NUMMER 829309
VERWENDET FÜR
WAR NR. E88-52544

DIMENSIONS: mm	DWN	17.07.89	MATERIAL	SEE TABLE	FINISH	SEE TABLE
	CHK	G.Holous				
TOLERANCES UNLESS OTHERWISE SPECIFIED:	APVD	M.Schaarschmidt	TE Connectivity			
	PRODUCT SPEC	—				
0 PLC ±0.2 mm		108-18012	NAME			
1 PLC ± -			SPEZ. AMPMODU II STIFTLISTE			
2 PLC ± -			ZWEIREIHIG			
3 PLC ± -			SIZE	CAGE CODE	DRAWING NO	RESTRICTED TO
4 PLC ± -			A4	00779	C-829309	—
ANGLES ± -			WEIGHT			
			CUSTOMER DRAWING			
			SCALE	SHEET	REV	
			4:1	1 OF 1	E

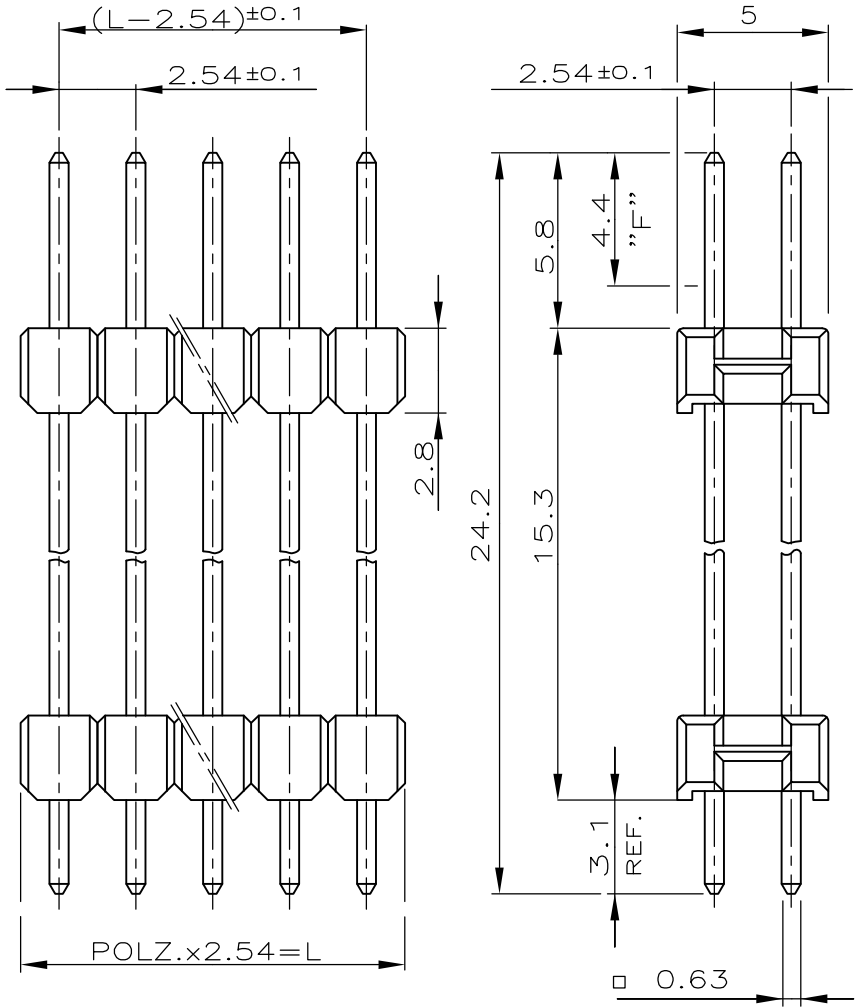
P	LTR	DESCRIPTION	DATE	DWN	APVD
E		Contact pin base material change from CuSn (Phosphor bronze) to CuZn (Brass). Plating change from MIN. 0.8µm gold plating to min. 0.7µm Pd Ni + 0.1µm gold flash at contact area (Area F).	22JUL2014	TJ	JK

STECKSEITE: IM BEREICH "F" 0.7µm PdNi+0.1µm GOLD FLASH ÜBER 1.27µm NICKEL
LÖTSEITE: MIN. 2.5µm ZINN ÜBER 1.27µm NICKEL

KONTAKTSTIFT	CuZn	1
STIFTGEHÄUSE	PBT	GRÜN
BENENNUNG	WERKSTOFF	OBERFLÄCHE FARBE
